## Determination 2014/029

### Regarding the refusal to issue a code compliance certificate for failure to comply with Building Code Clause F4 for a batter slope at 23 Melksham Drive, Churton Park, Wellington

**Figure 2: Cross section view of the property looking South**

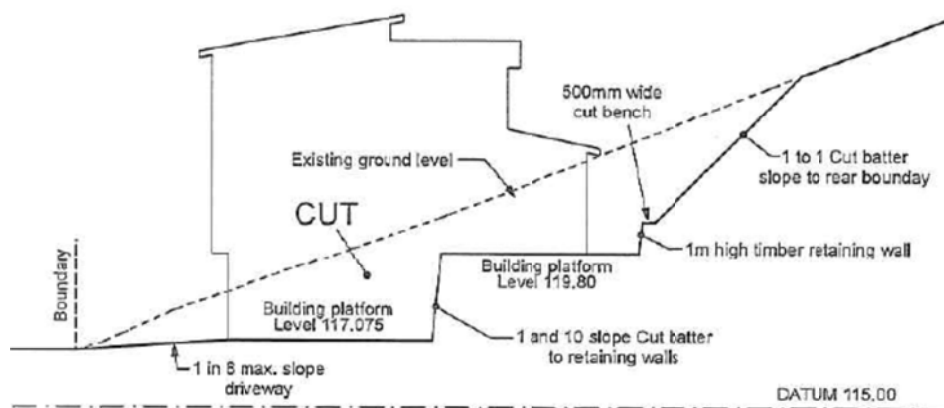
- 2.2 The excavation work has left a batter slope at approximately a 45-48 degree angle (refer to Figure 2). The top of the batter slope ranges between 6m to 14m to the rear boundary where the land has a 20 degree slope. The top of the batter to the north is very close to the boundary fence making access around the batter at this point difficult. The vertical height from the path behind the house to the top of the bank is approximately 5.2m.

- 5.3 I consider that the approximate 45 degree angle of the batter slope would constitute a ‘sudden’ change of level for the purposes of Clause F4.3.1, and accordingly the batter slope is subject to Clause F4. I do not consider whether or not the batter slope is exactly 45 degrees as an issue to be determined, nor does it have any bearing on the matter being determined.

- 5.6 The 1 metre fall height stated in Clause F4.3.1 recognises that falls from this height are likely to result in significant injury. The fall does not need to be vertical; a slope of 45 degrees is steep enough for someone to tumble down and injure themselves.<sup>8</sup> The batter slope in this instance is approximately 45 degrees, and there is no dispute that the fall is more than 1 metre.
- 5.7 In my view I need to consider the risk of falling as it is now, and as it is reasonably foreseeable with the adjacent residential sites complete with houses.

- 5.10 I therefore consider that some measure is required to mitigate the likelihood of a fall in the immediate term until the boundary fences are in place. The nature of this further measure is a matter for the applicants to propose and the authority to accept or reject. The parties may wish to refer to the Acceptable Solutions F4/AS1 paragraph 1.2.2 for guidance.<sup>9</sup> It is outside of the scope of this determination to conclude the type and specifications of these further measures to fulfil the requirements Clause F4, however, I consider a barrier is only required until such time as the remaining boundary fences are in place.

- 5.1 I consider a barrier is needed until the two remaining boundary fences are built. In relation to ongoing safety, once the boundary fences are in place the barrier required for the batter slope can be removed. In my view I do not consider that there needs to be both the two boundary fences and a barrier for the batter slope to comply with Building Code Clause F4.3.1.
